Recall Campaign Bulletin

Campaign No. 2024010011, July 2024

Revision B: 08/12/2024

Replace Fuel Pump Delivery Module – Wave 4

Figure 2

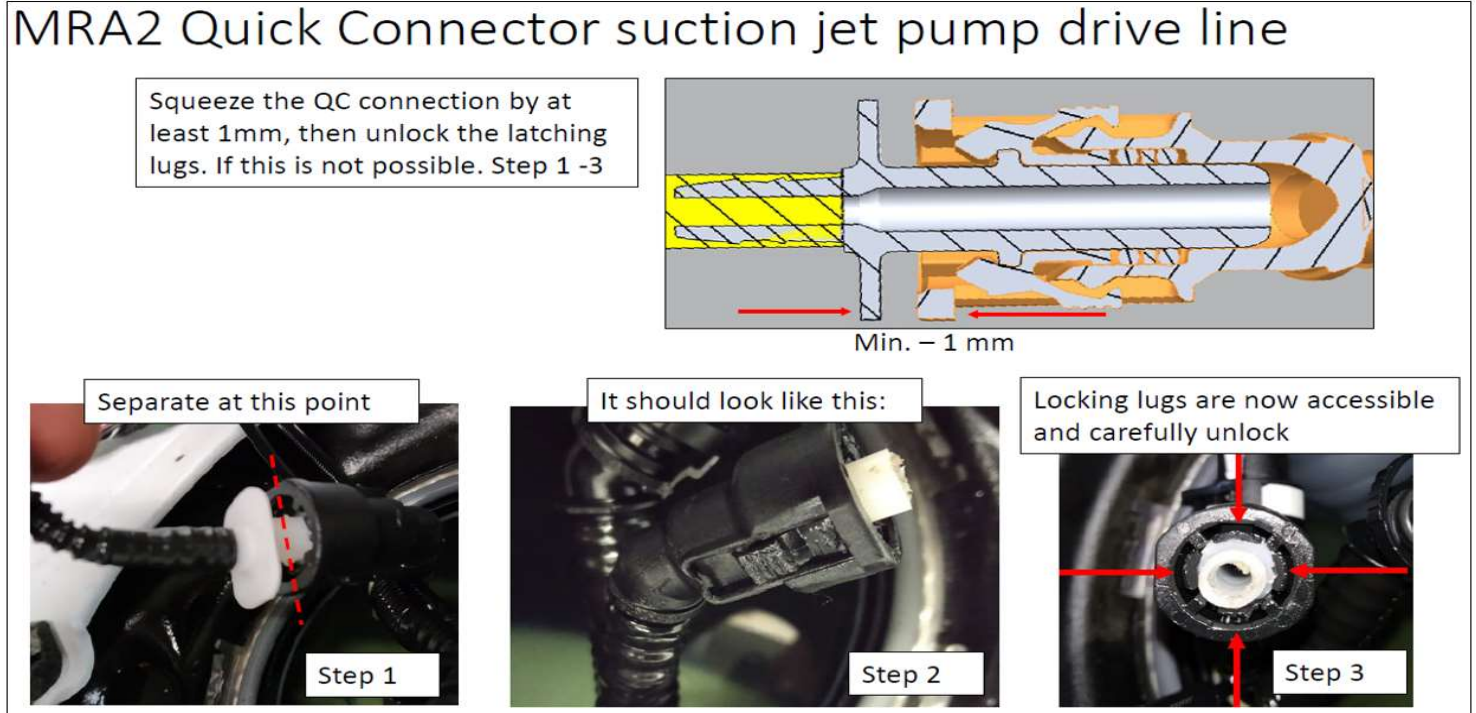
i Only model 206, 232: Note on disassembly of suction jet pump drive line quick connector.

The procedure steps 1-3 should only be performed when the quick disconnect is not working (**Figure 2**).

Figure 4 (remove electric lines from routing clip)

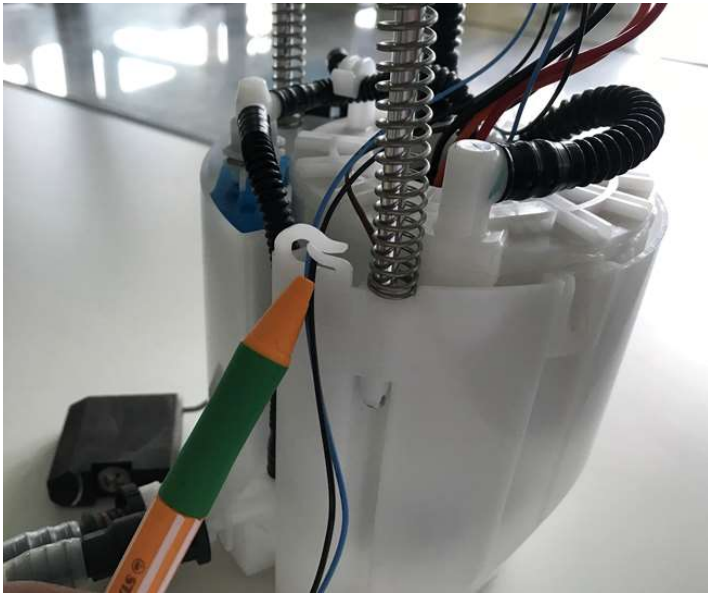
i Delivery modules that are delivered **without float-and-lever sensor** must be modified. (**Figure 4-7**)
